PLANT NAME: Oconee Unit 1 & 2

Re: Oconee Units 1 and 2
Docket Nos. 50-269 and 50-270

INFORMATION FOR REVIEW OF REQUESTED MODIFICATIONS
TO TECHNICAL SPECIFICATIONS 3.2.5.4 AND 3.5.2.5

PROPOSED REPLACEMENT PAGES FOR THE
OCONEE NUCLEAR STATION TECHNICAL SPECIFICATIONS

CONTROL ROD GROUP WITHDRAWAL LIMITS FOR 4 PUMP OPERATION

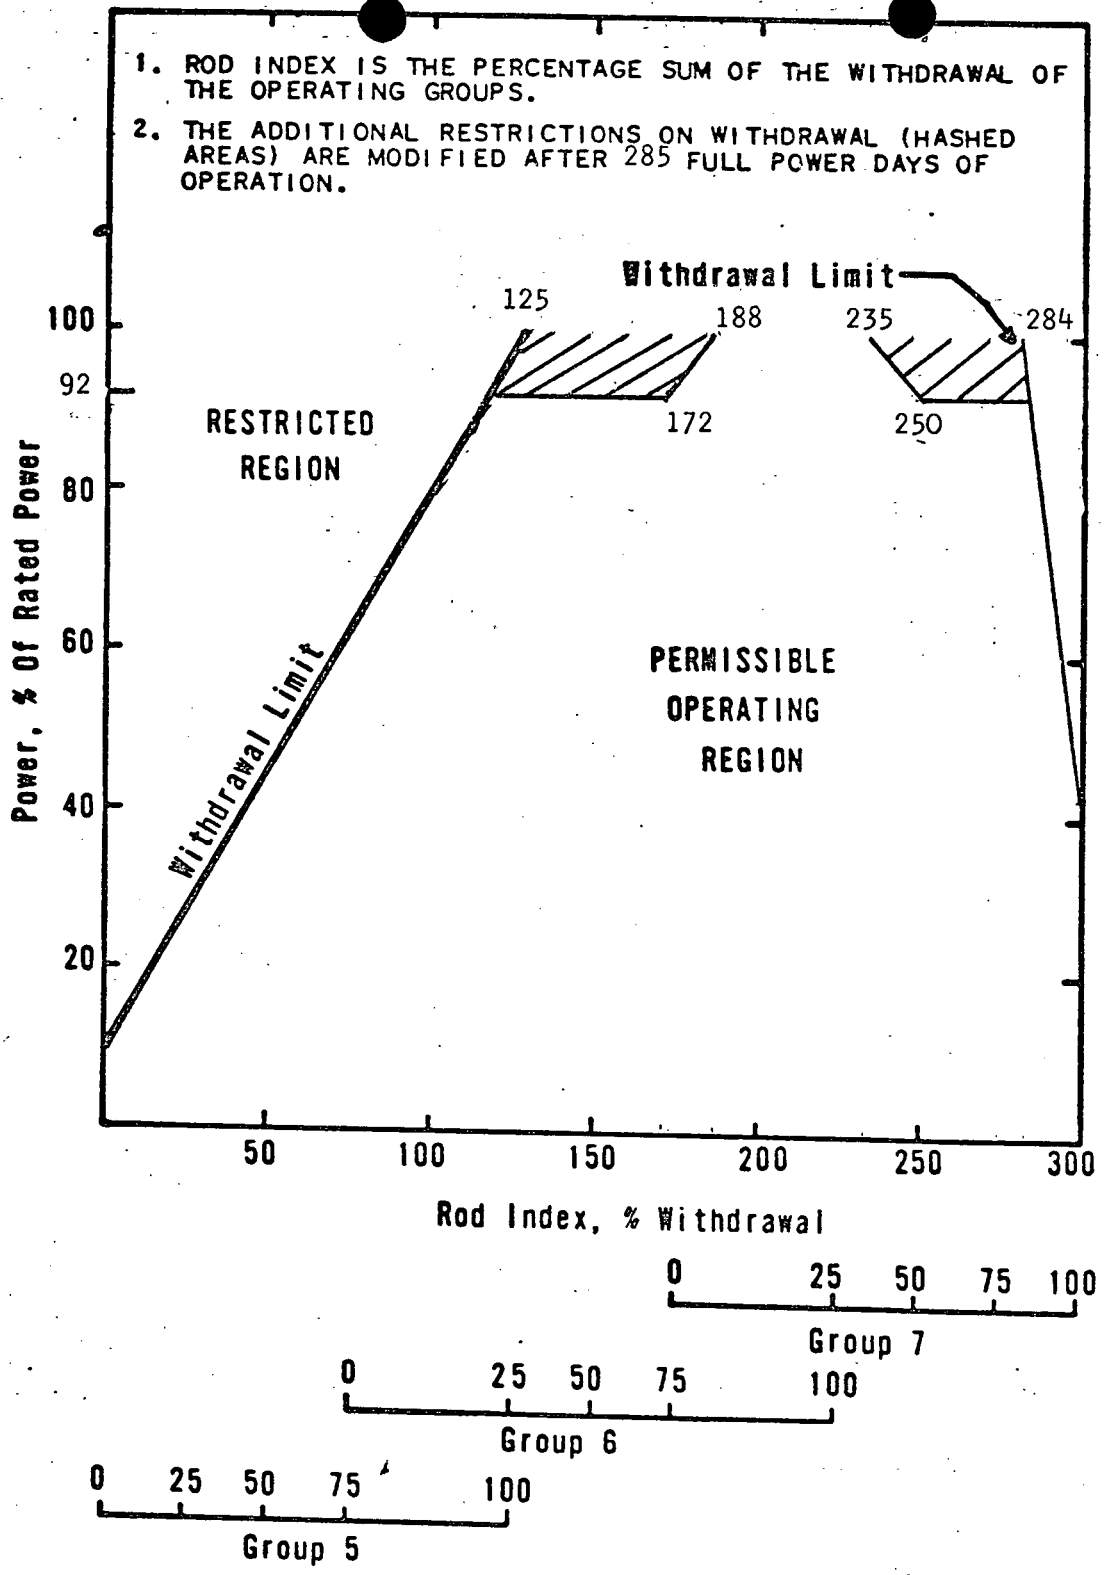
- 1. The protection system maximum allowable setpoints (Figure 2.3-2A-Unit 1) shall be reduced 2% in power for each 1% tilt.
 - 2. The control rod group withdrawal limits (Figures 3.5.2-1A1, 3.5.2-1A2, 3.5.2-2A Unit 1; 3.5.2-1B, 3.5.2-1B2, 3.5.2-2B Unit 2) shall be reduced 2% in power for each 1% tilt in excess of 4%.

- c. Except for physics tests or exercising control rods, the control rod withdrawal limits are specified on Figures 3.5.2-1A1, 3.5.2-1B1, 3.5.2-1A2, and 3.5.2-1B2 for four pump operation and on Figure 3.5.2-2A and 3.5.2-2B for three or two pump operation. If the control rod position limits are exceeded, corrective measures shall be taken immediately to achieve an acceptable control rod position. Acceptable control rod positions shall be attained within four hours.

Figure 3.5.2-1A2

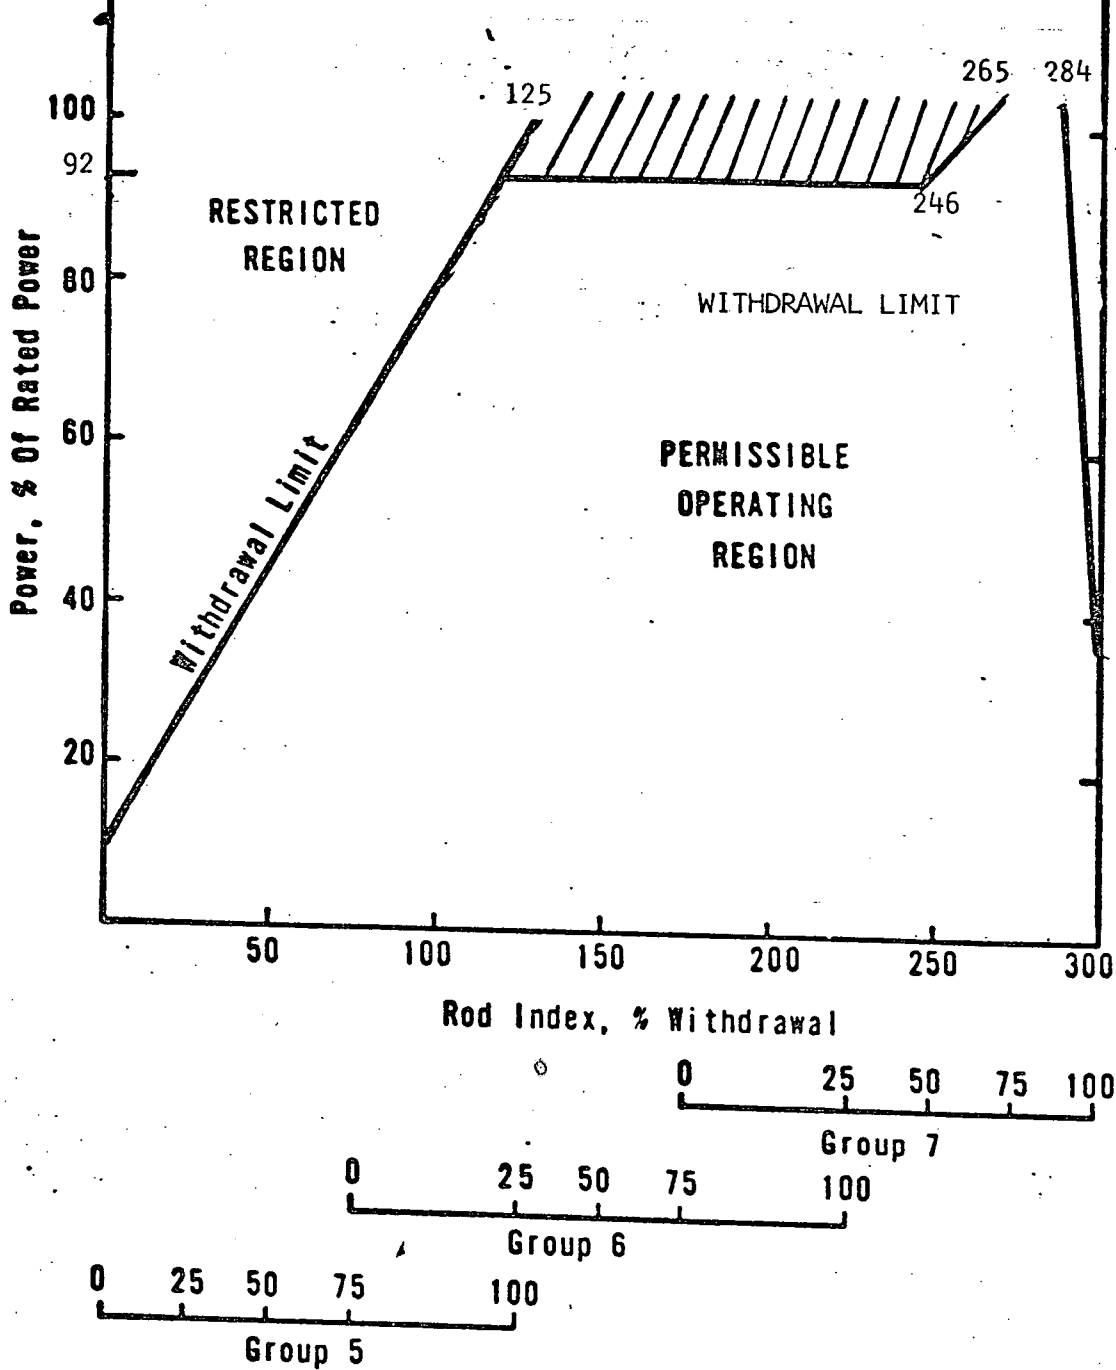
1. ROD INDEX IS THE PERCENTAGE SUM OF THE WITHDRAWAL OF THE OPERATING GROUPS.
2. THE ADDITIONAL RESTRICTIONS ON WITHDRAWAL (HASHED AREAS) ARE IN EFFECT AFTER 285 FULL POWER DAYS OF OPERATION.

UNIT 1
 OCONEE NUCLEAR STATION
 Figure 3.5.2 - 3 A

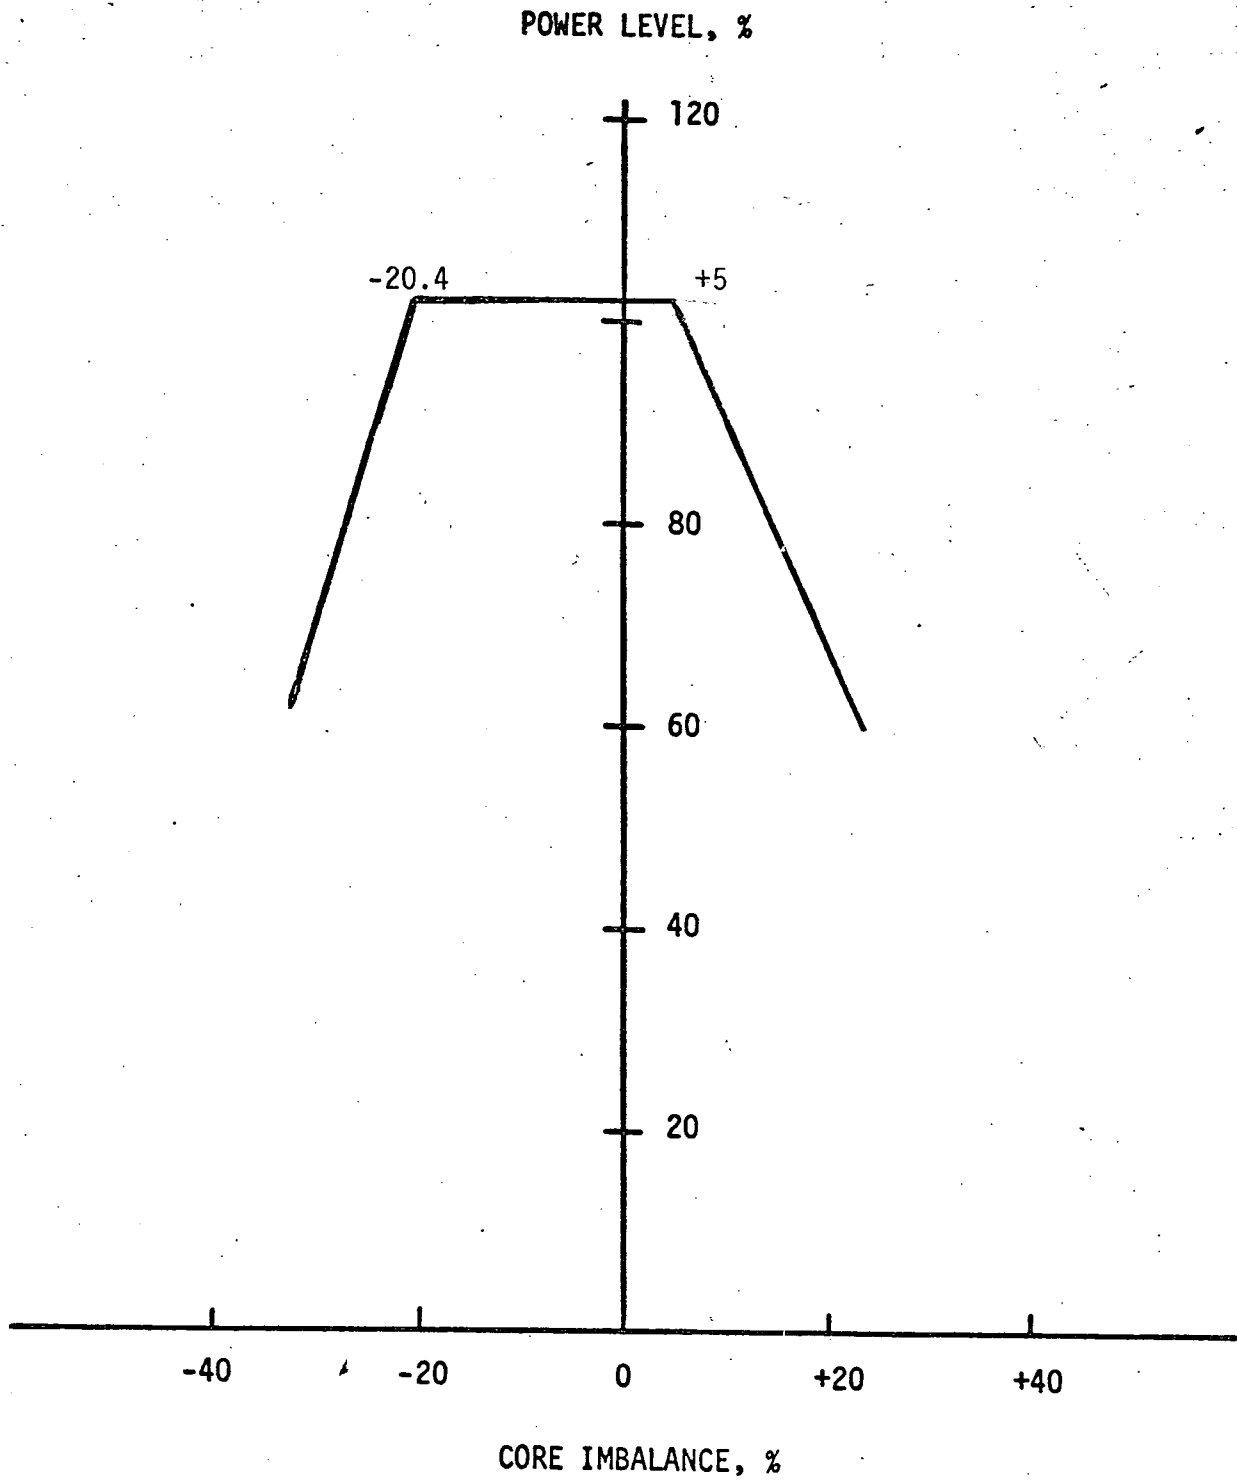
- 3. The operational imbalance limits (Figure 3.5.2-3A-Unit 1; 3.5.2-3B-Unit 2) shall be reduced 2% in power for each 1% tilt in excess of 4%.
- c. If quadrant tilt is in excess of 25%, except for physics tests or diagnostic testing, the reactor will be placed in the hot shutdown condition. Diagnostic testing during power operation with a quadrant power tilt is permitted provided the thermal power allowable for the reactor coolant pump combination is restricted as stated in 3.5.2.4a above.

- e. Reactor Power Imbalance shall be monitored on a frequency not to exceed two hours during power operation above 40 percent rated power. Except for physics tests, imbalance shall be maintained within the envelope defined by Figure 3.5.2-3A and 3.5.2-3B. If the imbalance is not within the envelope defined by Figure 3.5.2-3A and 3.5.2-3B, corrective measures shall be taken to achieve an acceptable imbalance. If an acceptable imbalance is not achieved within four hours, reactor power shall be reduced until imbalance limits are met.

The power-imbalance envelope defined in Figure 3.5.2-3A and 3.5.2-3B is based on LOCA analyses which have defined the maximum linear heat rate (see Figure 3.5.2-4) such that the maximum clad temperature will not exceed the interim Acceptance Criteria. Corrective measures will be taken immediately should the indicated quadrant tilt, rod position, or imbalance be outside their specified boundary. Operation in a situation that would cause the interim acceptance criteria to be approached should a LOCA occur is highly improbable because all of the power distribution parameters (quadrant tilt, rod position, and imbalance) must be at their limits while simultaneously all other engineering and uncertainty factors are also at their limits.* Conservatism is introduced by application of:
